ADDENDUM NO.2

PROJECT: Carey Station Urban Water Reuse Facility 0.5 MGD to 1.0 MGD Expansion
For Piedmont Water Company
GMC PROJECT NO. CAUG230002

Appendix A

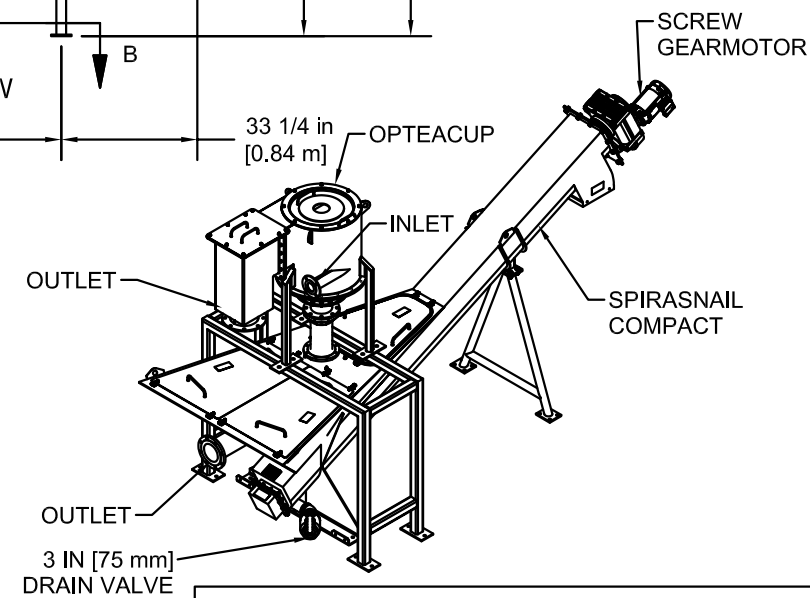
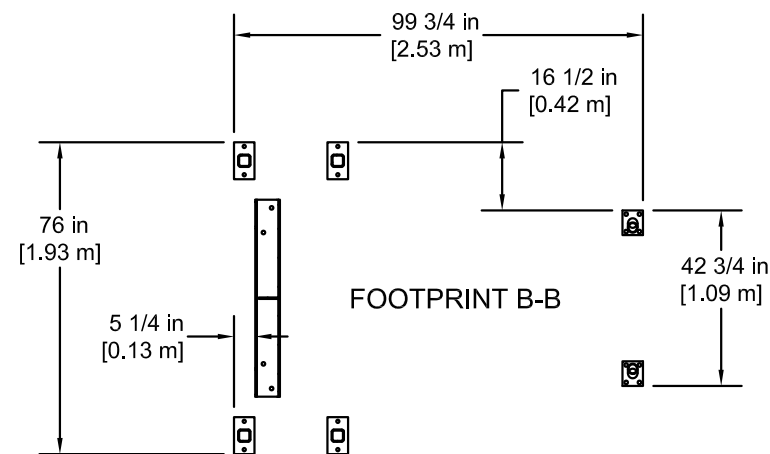
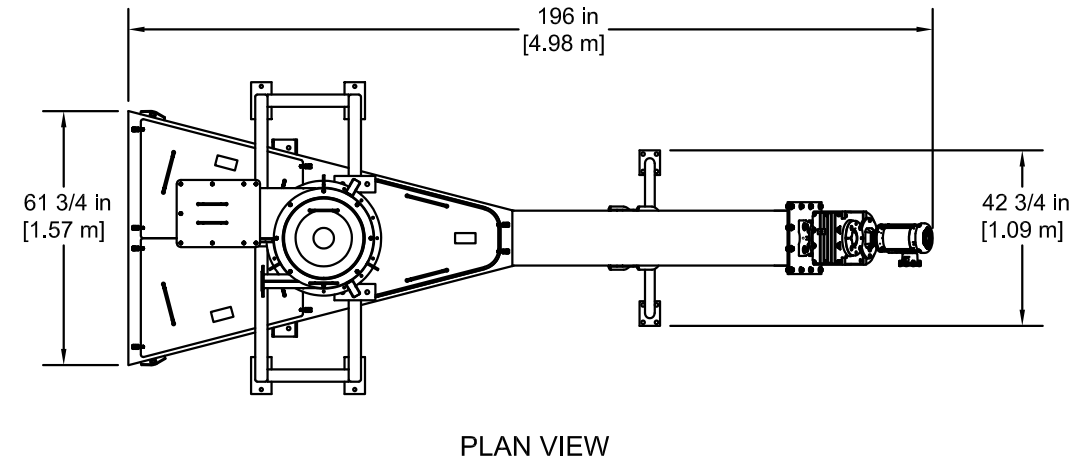
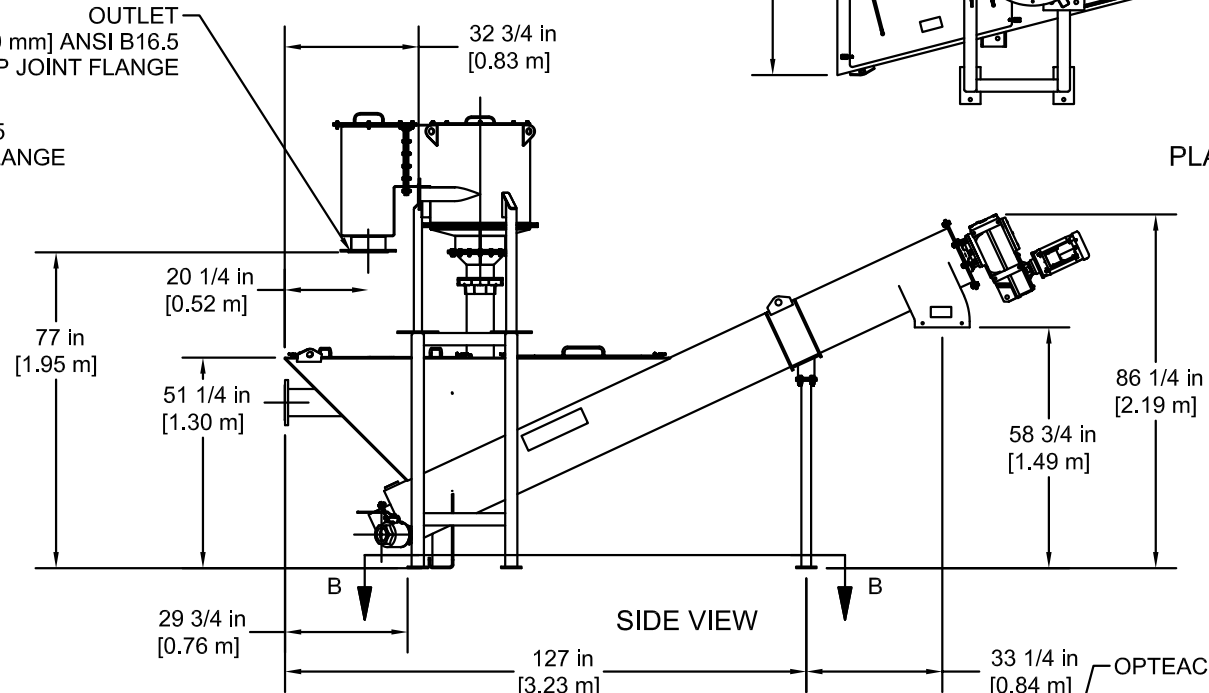
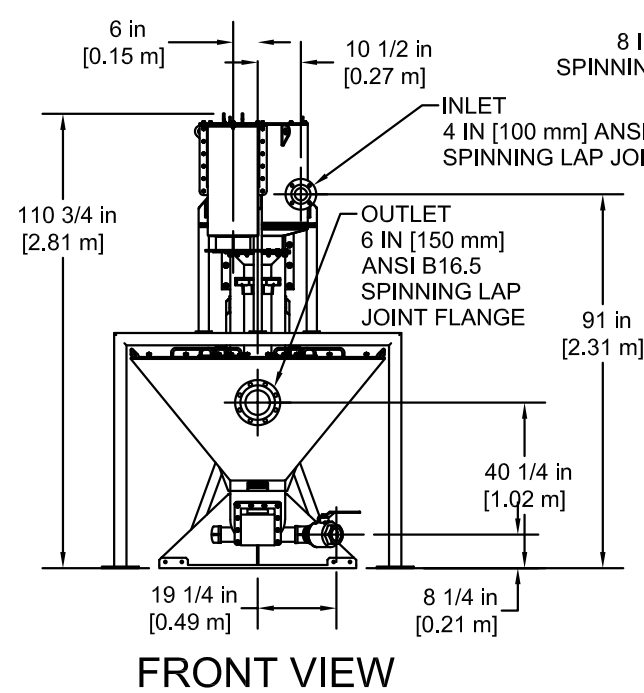
- 1.23 **D-101 to D-105 does not show a section cut through the grit washer compactor. Can this be provided?**

Answer: See Appendix A with section views.
